Docket Number:	15-AFC-01
Project Title:	Puente Power Project
TN #:	206310
Document Title:	Applicant's Responses to City of Oxnard Data Requests, Set 2 (47-67)
Description:	N/A
Filer:	Paul Kihm
Organization:	Latham & Watkins LLP
Submitter Role:	Applicant Representative
Submission Date:	10/8/2015 4:29:47 PM
Docketed Date:	10/8/2015

Puente Power Project (P3)
Oxnard, CA

**Responses to City of Oxnard
Data Requests Set 2 (47-67)**

**Table 47-2
Cumulative Inundation Sources
at the P3 Site and Corresponding Annual Probabilities**

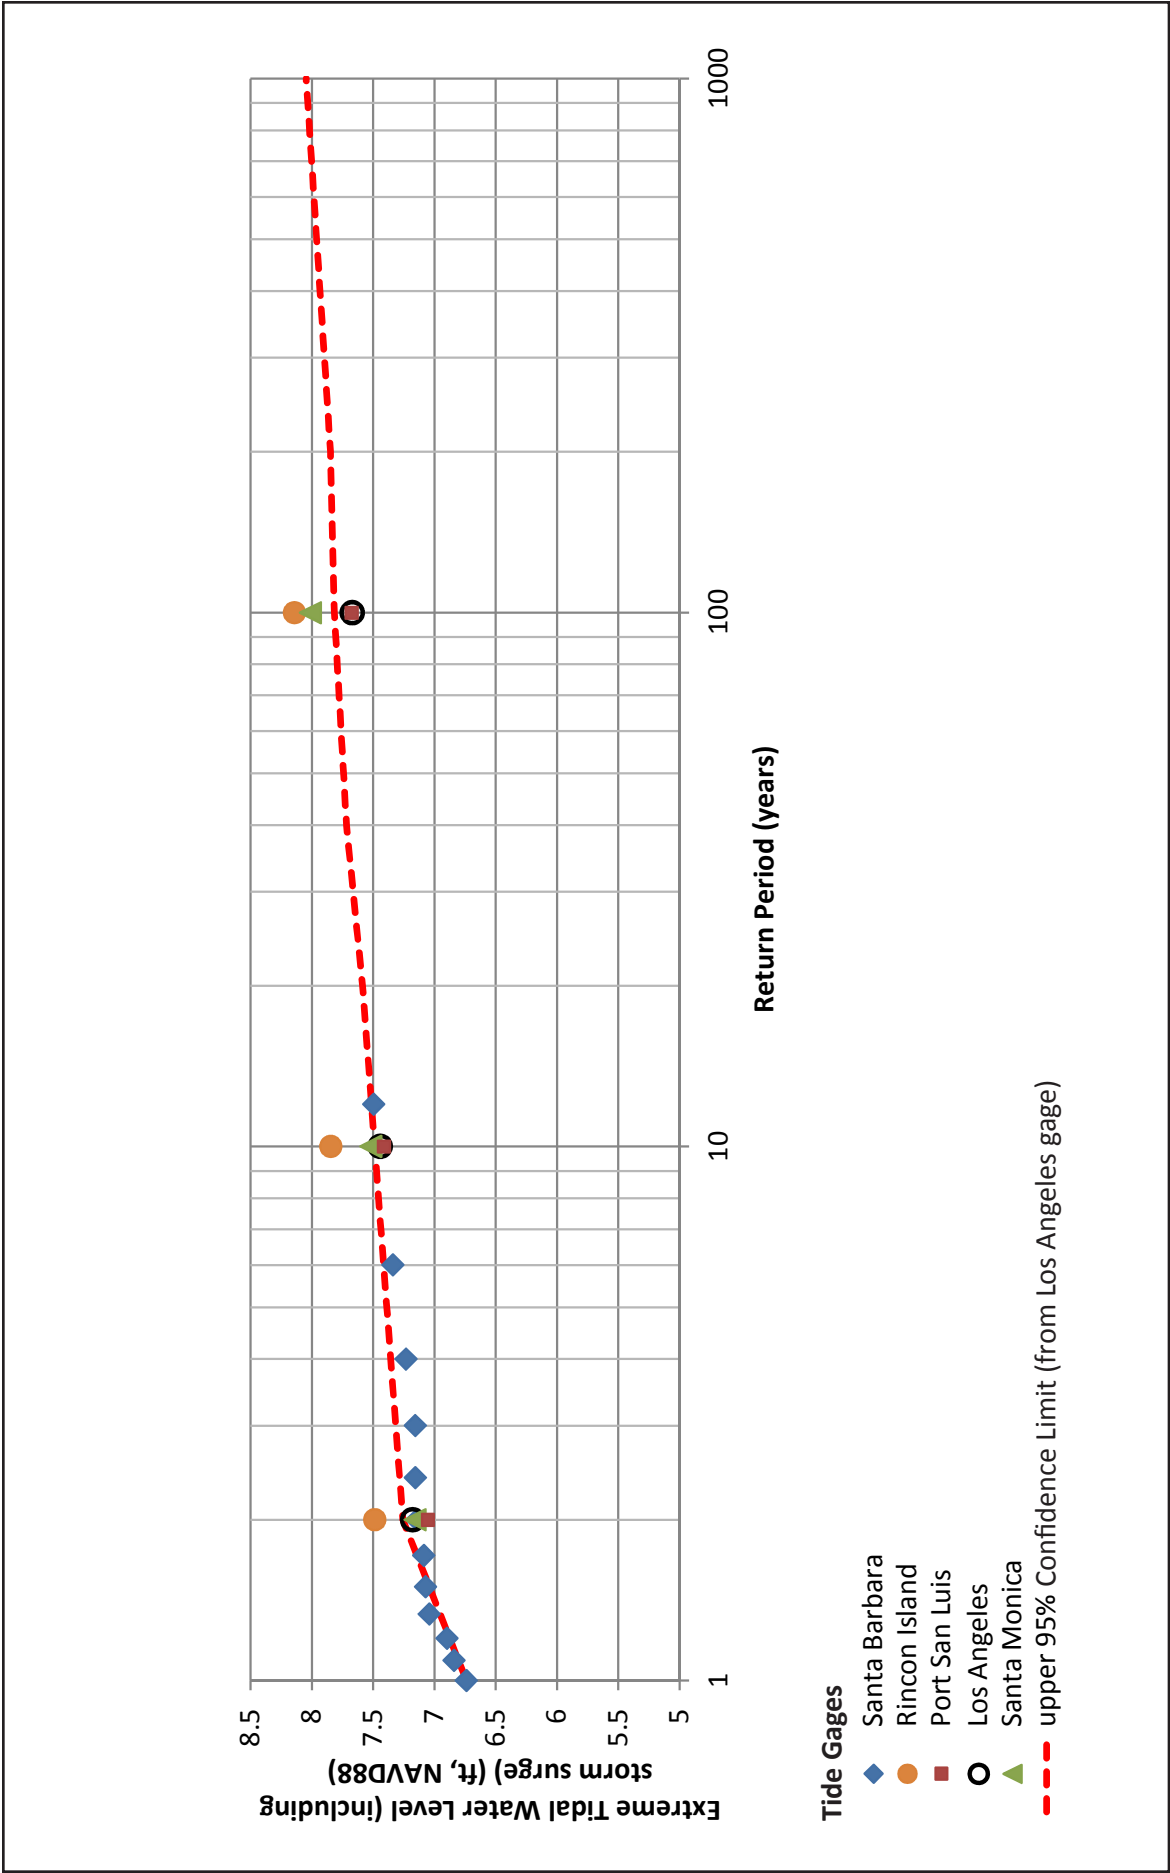
47. *Please revise the sea level rise analysis in Appendix N-2 to include the cumulative effect of a tsunami, wave and storm surge flooding, dune erosion, and riverine inundation. Your analysis should report the cumulative rise in feet above mean sea level for the combined impact.*

Table 47-2 shows the water-surface elevation for selected return periods and annual probabilities for various inundation sources. This allows estimates of water levels for different combinations of inundation sources. For example, the maximum water level, assuming a

100-year tide with storm surge plus 100-year wave, is 17.91 feet, with a return period of 10,000 years (100 years times 100 years). For the case with a tsunami from the Goleta #2 landslide plus a 100-year extreme tide plus a 100-year high wave, the water level would be 32 feet, with a return period of 100 million years (10,000 ´ 100 ´ 100).

FIGURE 47-3

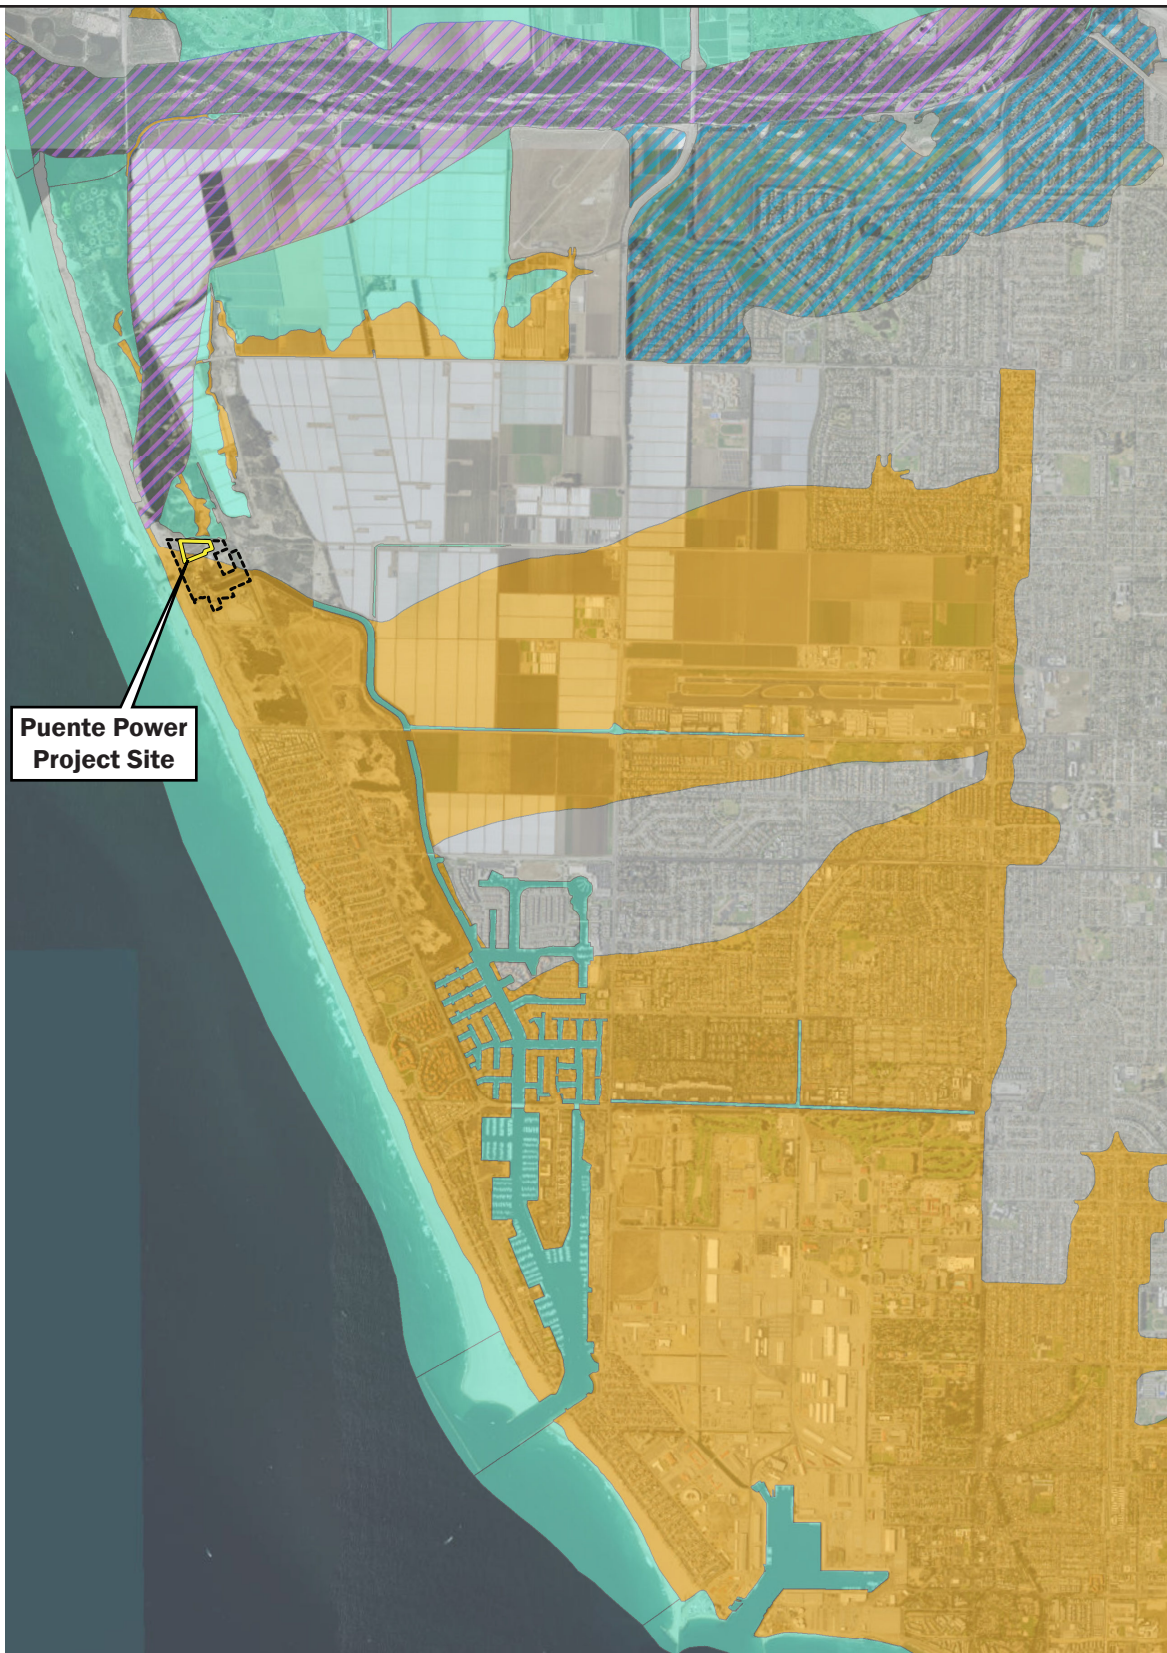
- 49. The sea level rise analysis failed to consider the impact of flooding from the Edison Canal. Please revise the analysis to consider the cumulative effect of a tsunami, wave and storm surge flooding, riverine inundation, dune erosion, and Edison Canal flooding.**

The current effective Federal Emergency Management Agency (FEMA) maps show the northern portion of the MGS property, where the proposed project will be sited, in a minimal flooding zone; and the remaining portion of the MGS property in the 0.2 percent annual floodplain (commonly referred to as the 500-year floodplain). Based on a detailed review of the FEMA flood map, it appears the 500-year floodplain is due to local flooding, and is not associated with the Santa Clara River floodplain. Therefore, no riverine water levels were considered (see Figure 47-3). The 1 percent annual chance flood is shown to be contained within the Edison Canal.

FEMA maps (see Figure 47-3) do not indicate flooding along the Edison Canal from riverine sources, so there would be no increase in water level in the canal from riverine flooding.

FIGURE 50-1

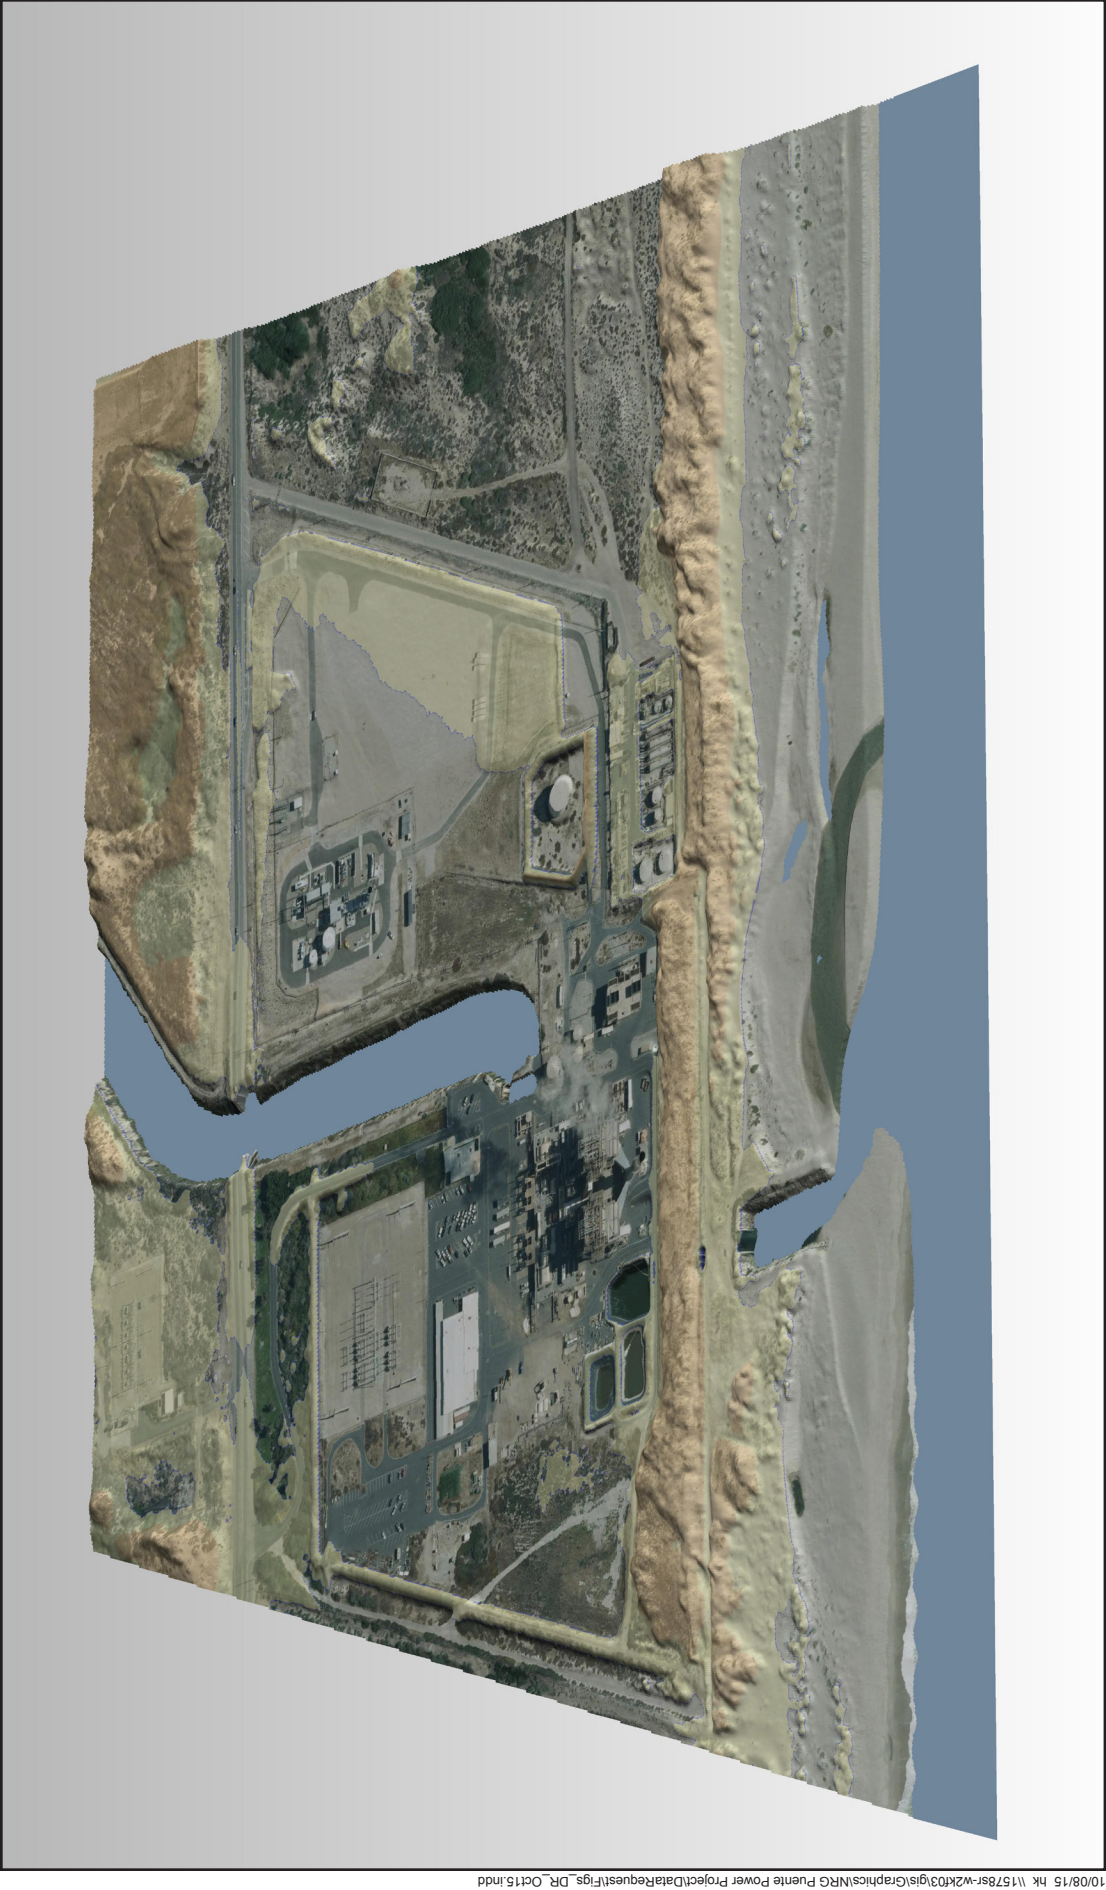
- 50. *The sea level rise analysis is difficult to evaluate without a detailed topographic map showing the elevation of the dunes and levees protecting the Project site. Please provide a detailed topographic map and three dimensional diagram showing dune and levee elevation and project site elevations.***

The detailed existing topographic map for the entire MGS, including the proposed project site, is shown on AFC Figure 2.4-2. A three-dimensional image based on this topographic survey information and the LiDAR data is provided as Figure 50-1.

FIGURE 54-1

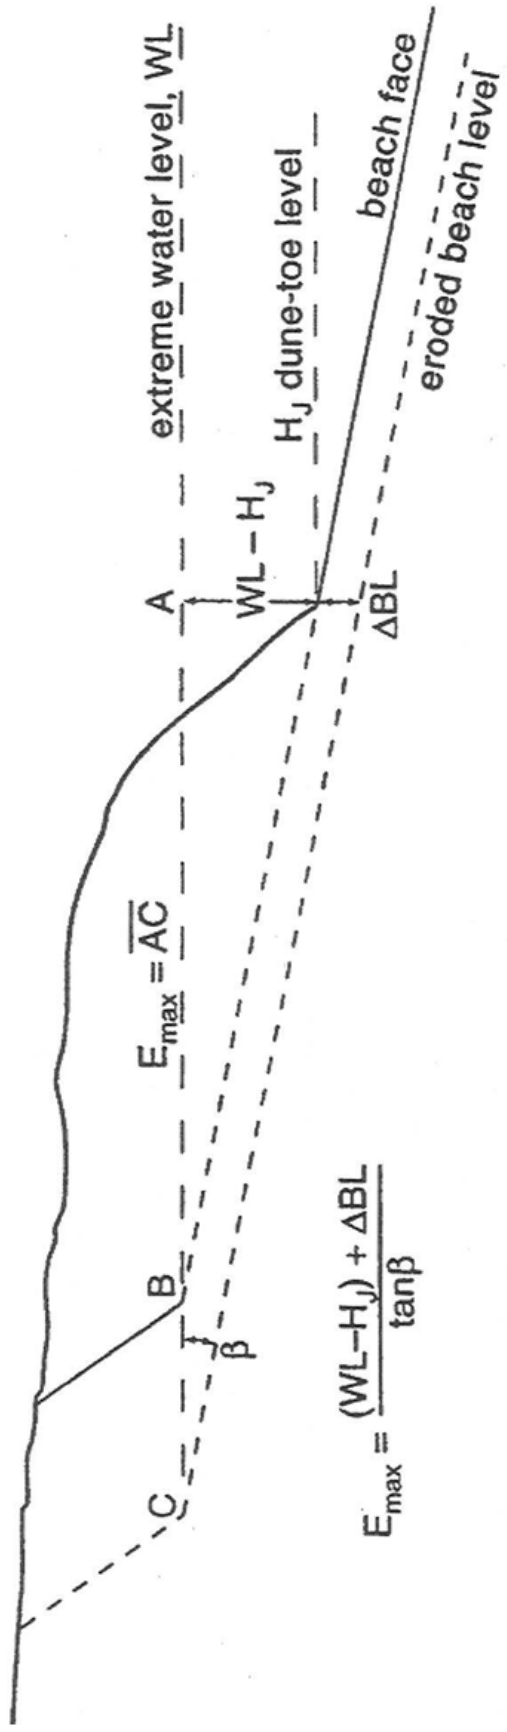
54. Please provide any analysis conducted by NRG or its consultants of erosion of the coastal dunes that abut the Mandalay Bay site.

The Komar et al. (1999) method mentioned above was devised for predicting dune erosion, which the authors applied to the coast of Oregon to provide a rational analysis for setback distances to prevent development in areas of the greatest coastal hazards. The method is a simple geometric model based on the extreme water level, elevation of the toe of the dune, and slope of the beach. Figure 54-1 provides a diagram describing the model.
